# UNITED STATES PATENT AND TRADEMARK OFFICE

APPLICATION NO.	FILING DATE	FIRST NAMED INVENTOR	ATTORNEY DOCKET NO.	CONFIRMATION NO.
10/708,178	02/13/2004	Jian-Shen Yu	10929-US-PA	2177

<b>Office Action Summary</b>	<b>Application No.</b> 10/708,178	<b>Applicant(s)</b> YU ET AL.	
	<b>Examiner</b> Jimmy H. Nguyen	<b>Art Unit</b> 2629

### **DETAILED ACTION**

## Replacement Sheet

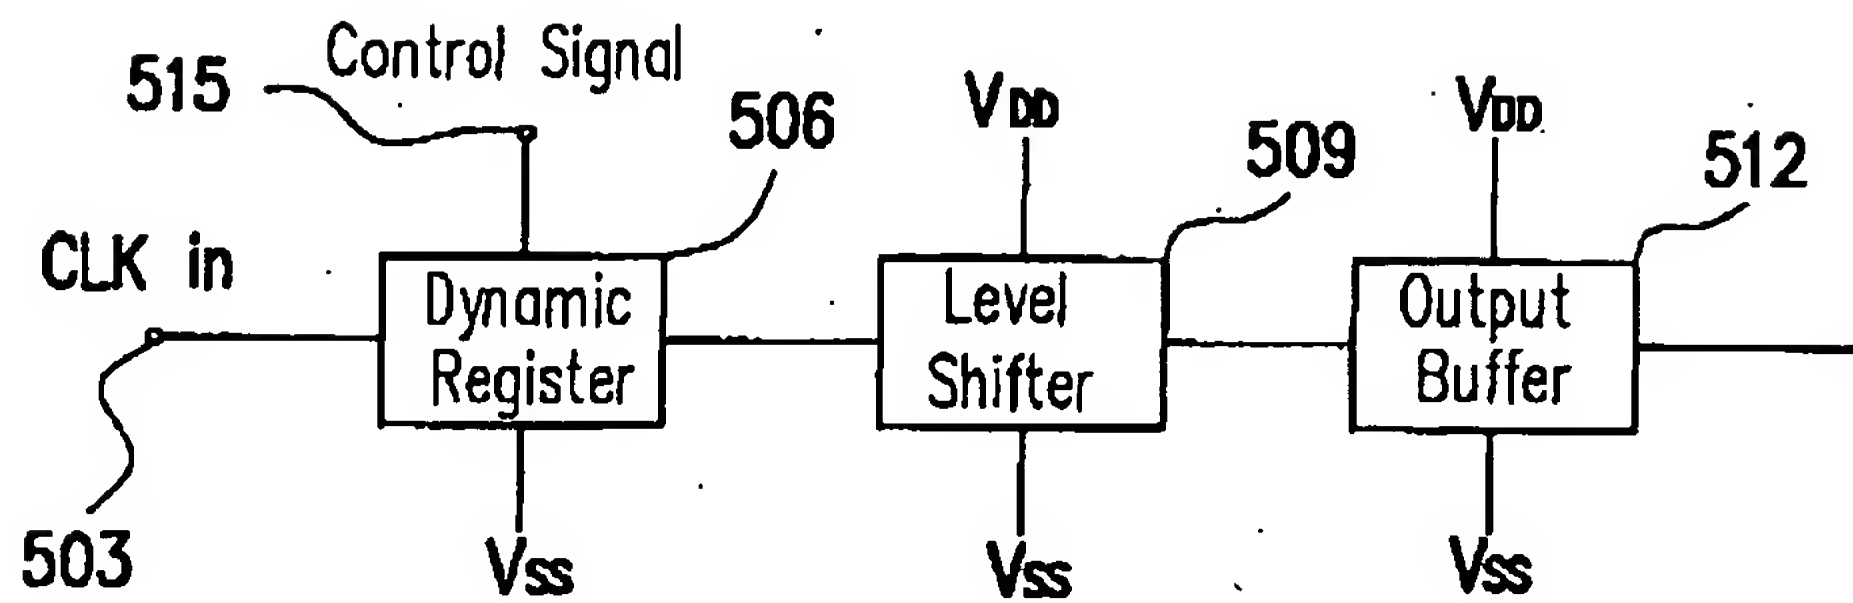
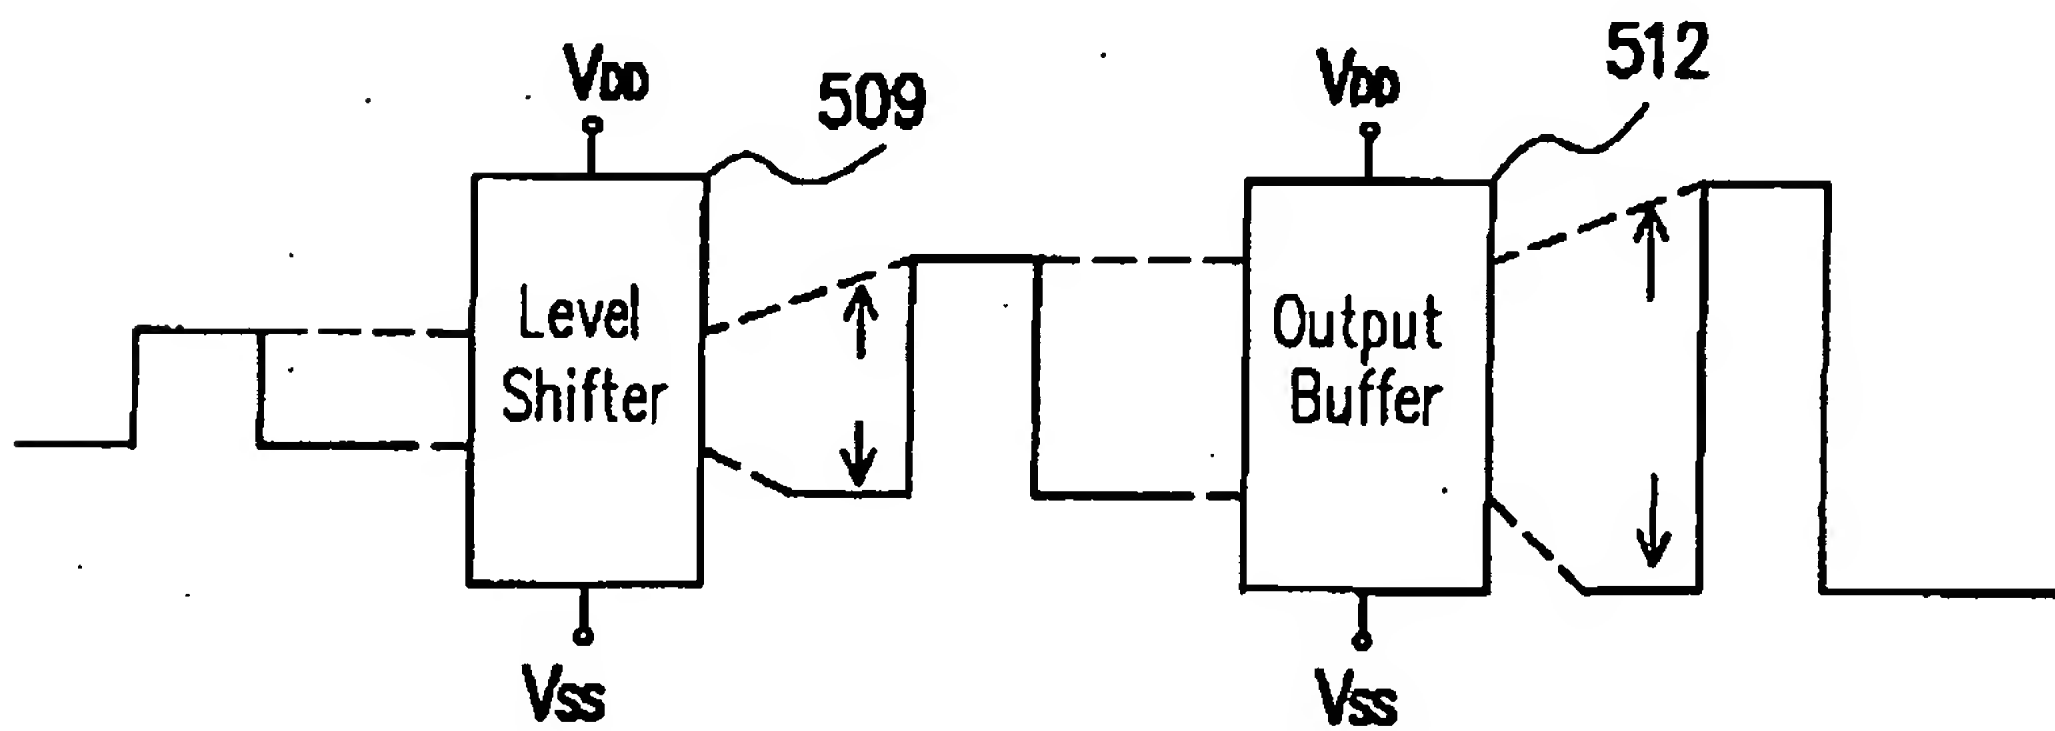
2. The drawing was received on 02/15/2007. This drawing is acceptable.
